UNITED STATES
NUCLEAR REGULATORY COMMISSION
WASHINGTON, D. C. 20555

APPLICANT: Public Service Electric & Gas Company (PSE&G)
FACILITY: Hope Creek Generating Station
SUBJECT: SUMMARY OF STRUCTURAL AND GEOTECHNICAL ENGINEERING
BRANCH (SGEB) MEETING

On August 1, 1984, a meeting was held in the Bethesda, Maryland offices of the NRC to discuss the remaining SGEB-Structural audit open items identified in the Draft SER. A list of meeting attendees is included as Enclosure 1 to this meeting summary.

FIGURE A-13-11

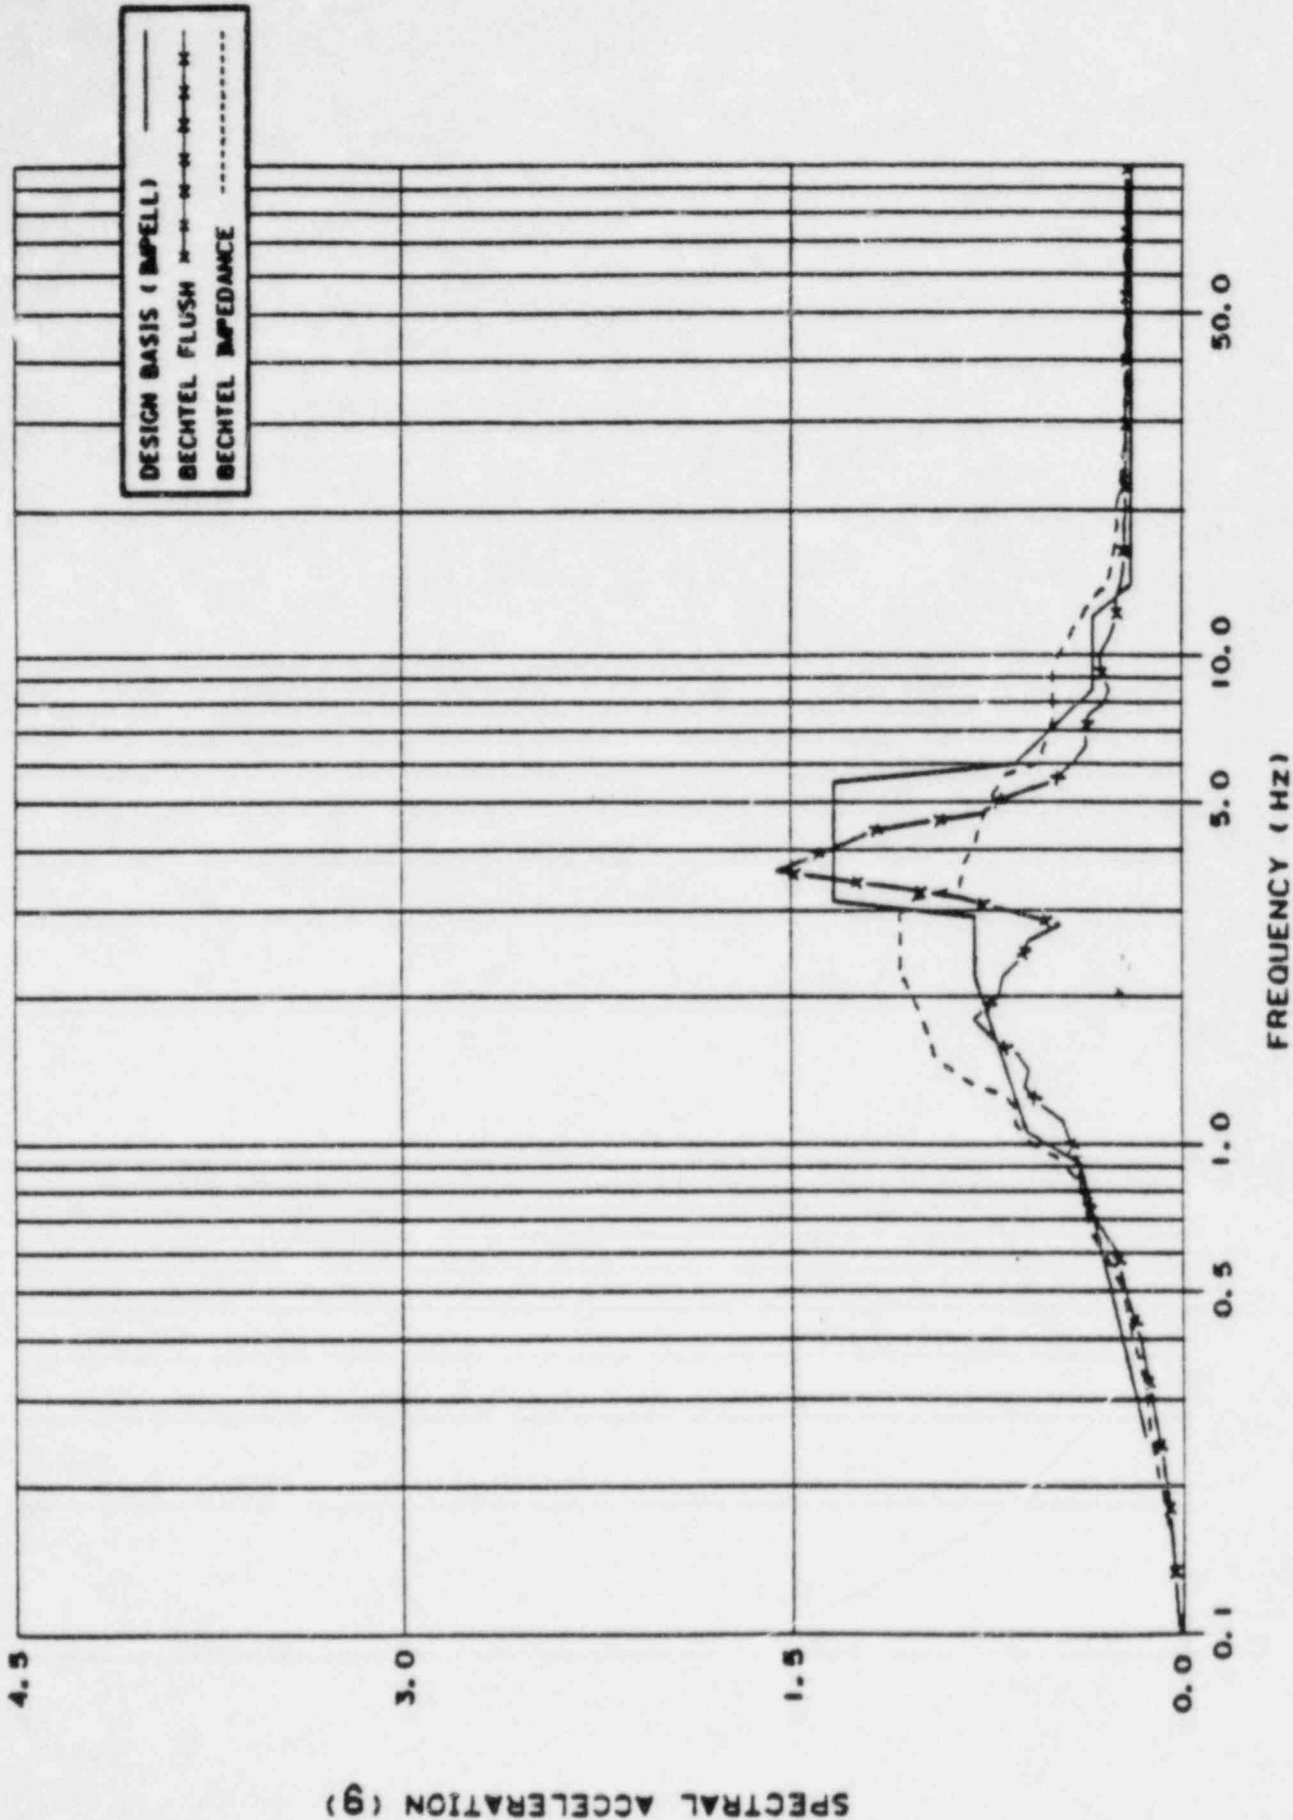
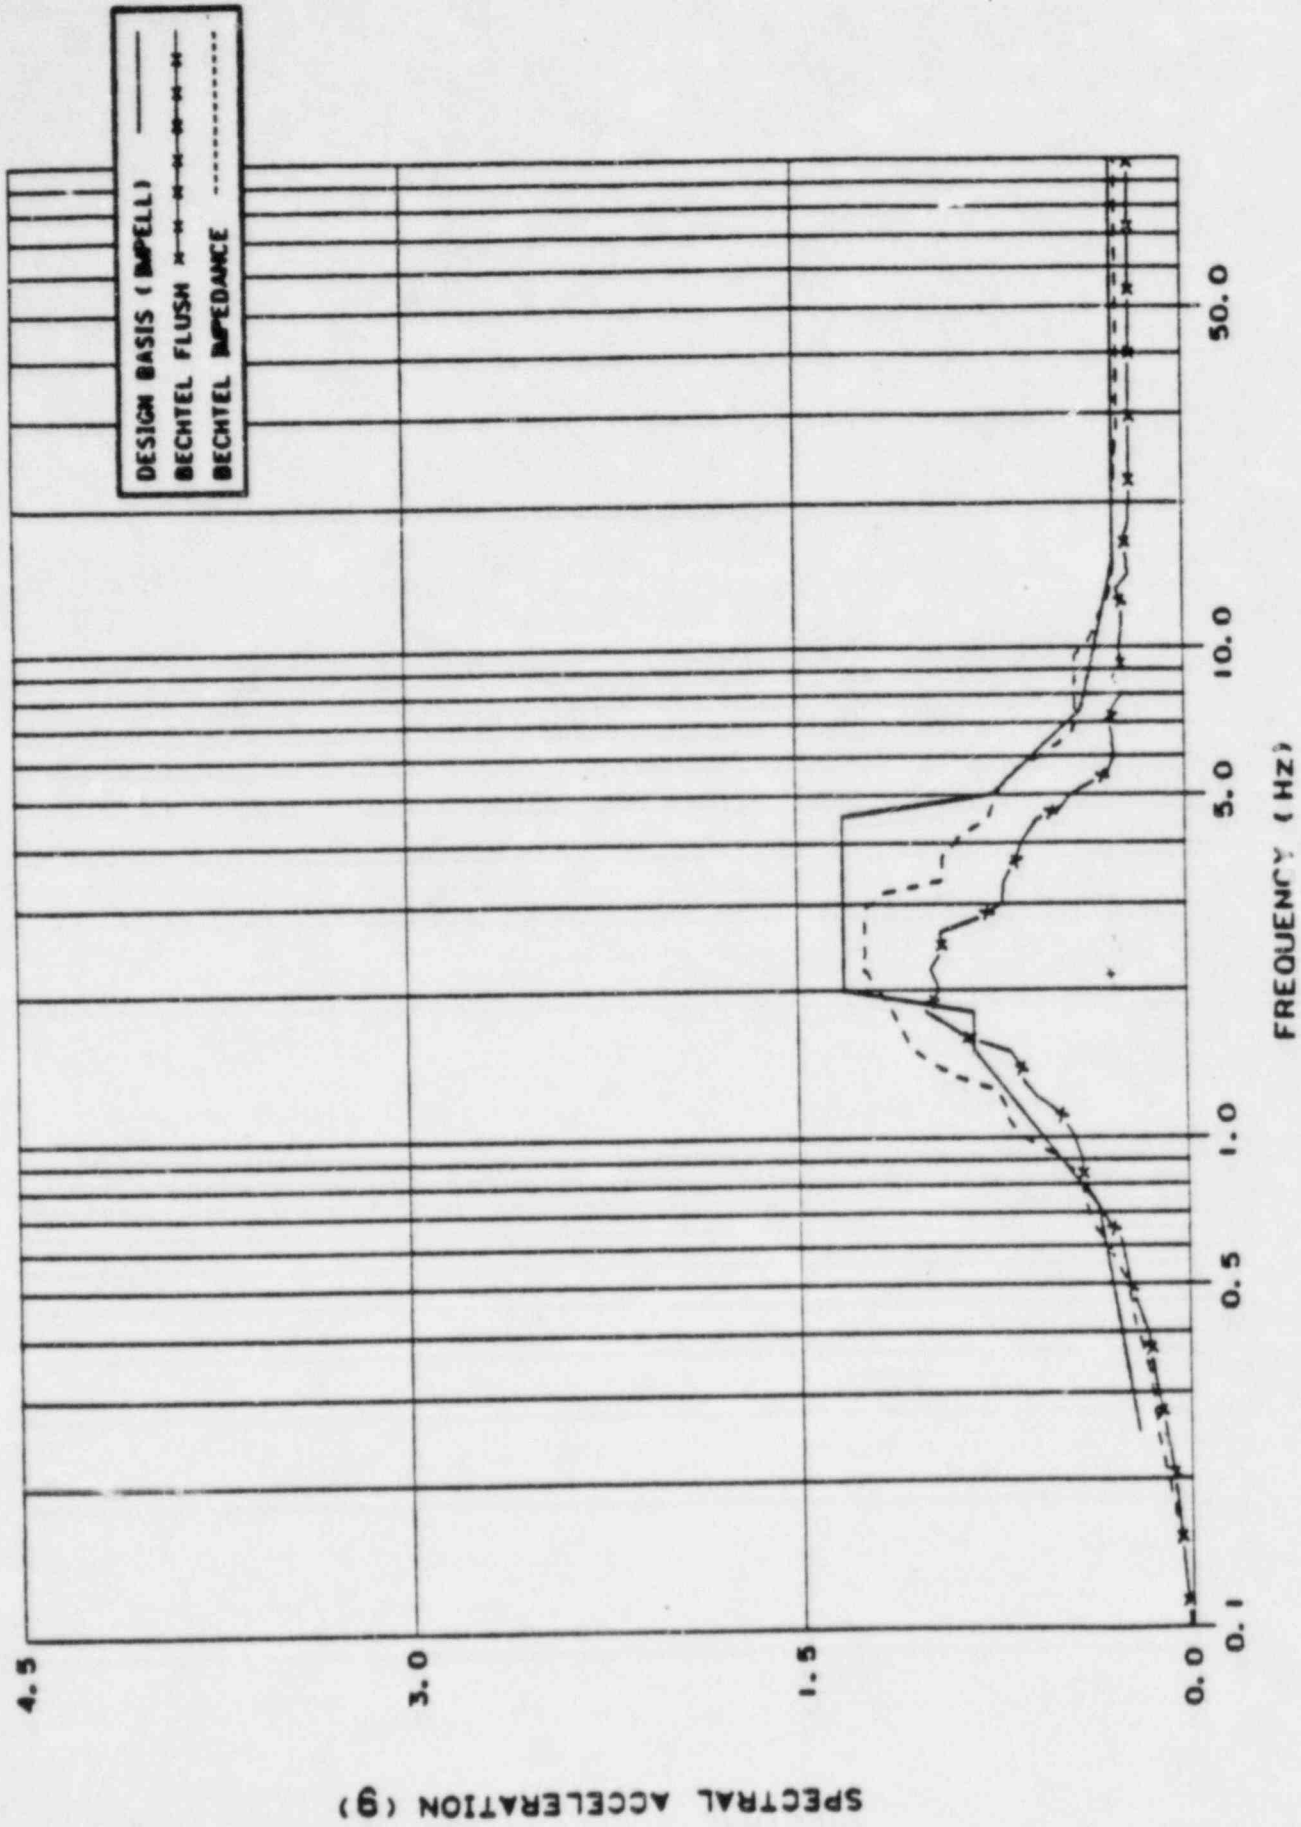
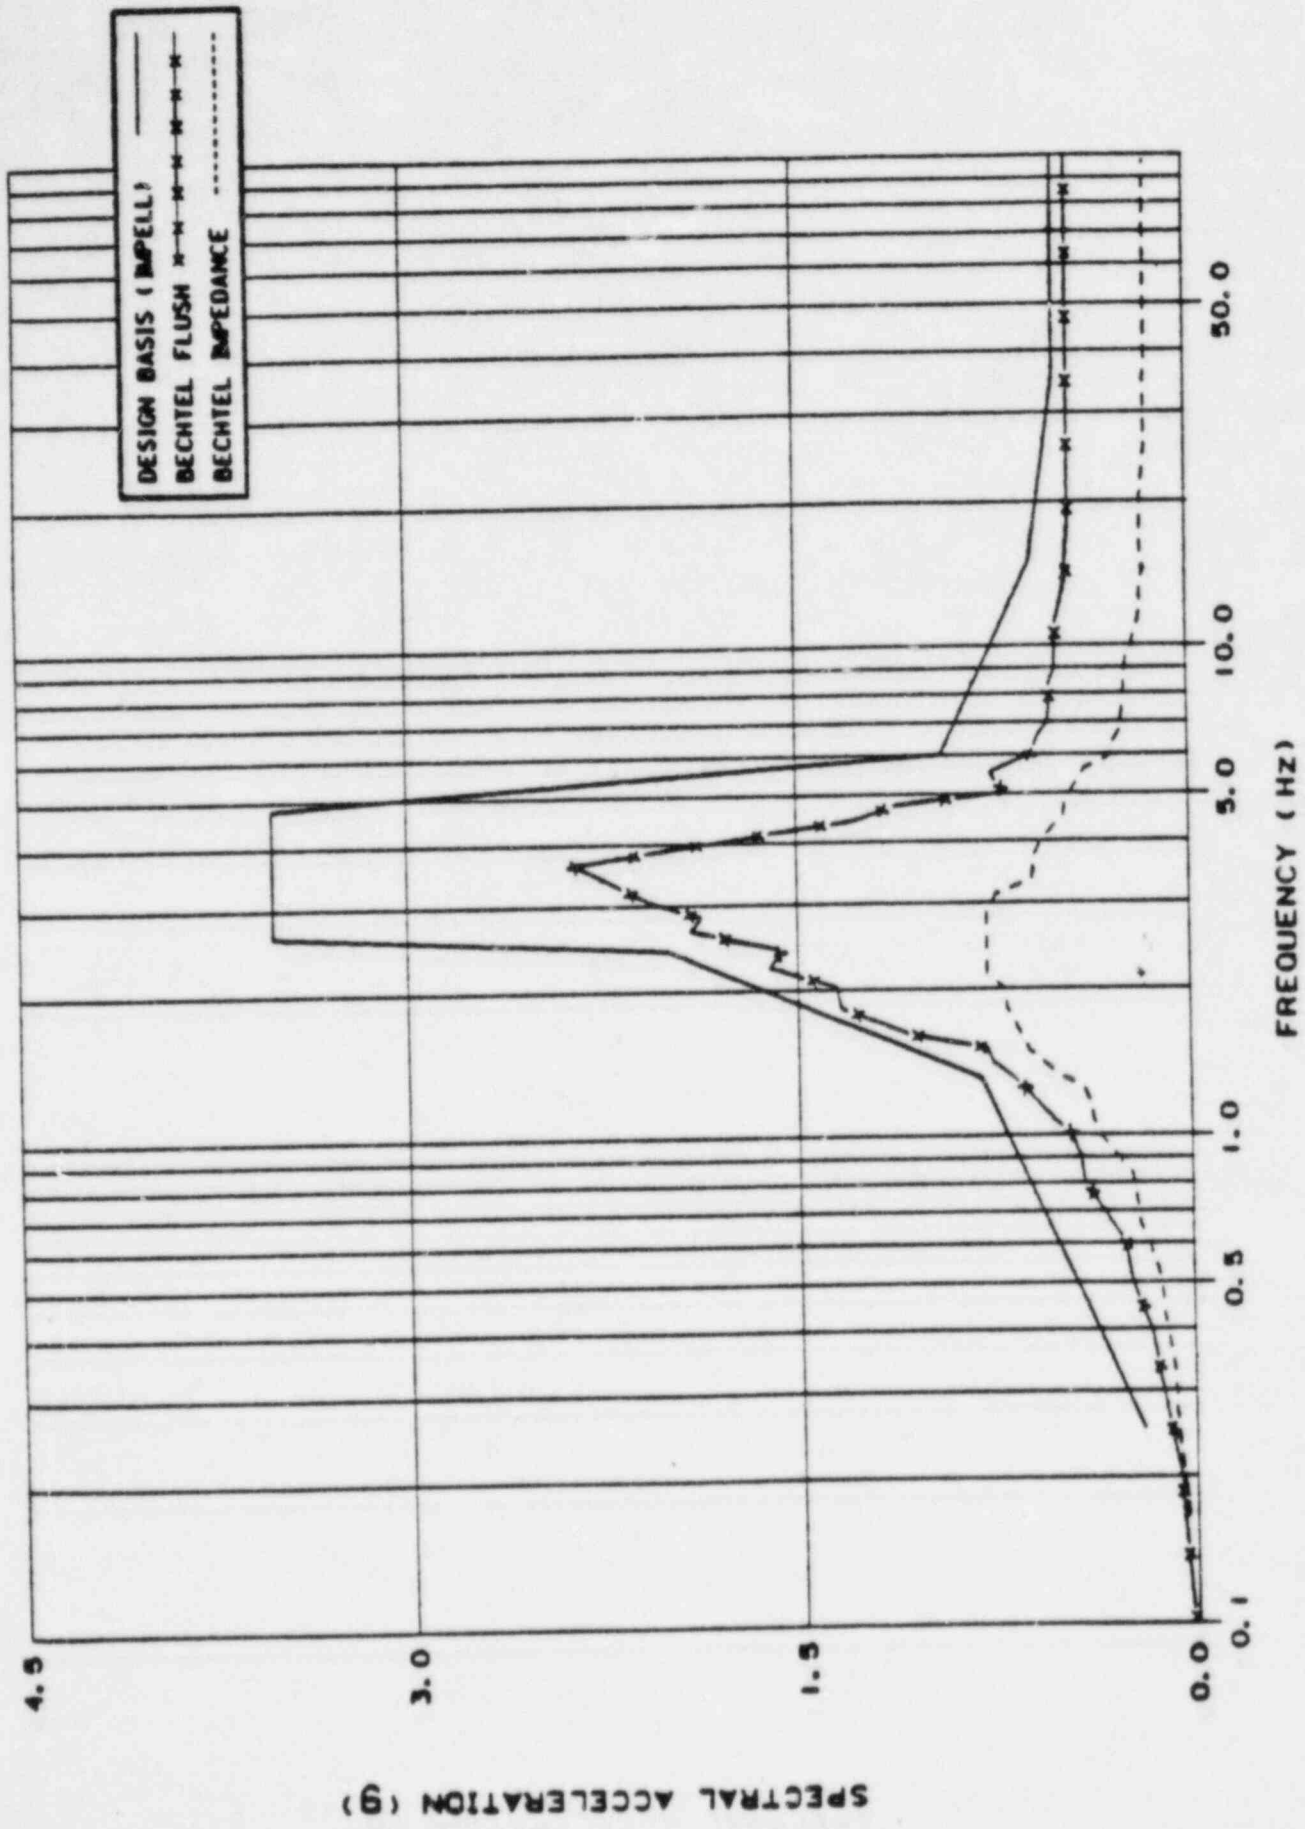
Question: Provide comparison of Bechtel Independent Verification Results with the Design Basis Results.

Figures A-13-2 to A-13-37 show the comparison of the response spectra (2% damping) obtained from the above three seismic soil-structure interaction analyses. Discussions of these comparisons are as follows:

Bechtel's independent soil-structure interaction analyses are performed using the computer code FLUSH. The results of independent finite element analyses are in reasonable agreement with those of the design basis analyses. As can be seen from Figures A-13-2 through A-13-37, the horizontal response spectra obtained from the independent finite element analyses are generally enveloped by those obtained from the design basis analyses except for the frequency range lower than 2 Hz. The vertical response spectra showed some exceedances at the frequency range of 18 Hz. These exceedances are listed in Table A-13-1.

The peak spectral accelerations obtained from the impedance approach analyses are generally lower than those obtained from the design basis analyses. However, these response spectra are not completely enveloped by those obtained from the design basis analysis, especially in the frequency range between 1.0 and 3.5 Hz. Also, there are some local exceedances in the higher frequency range, as shown in Figures A-13-2 through A-13-37.
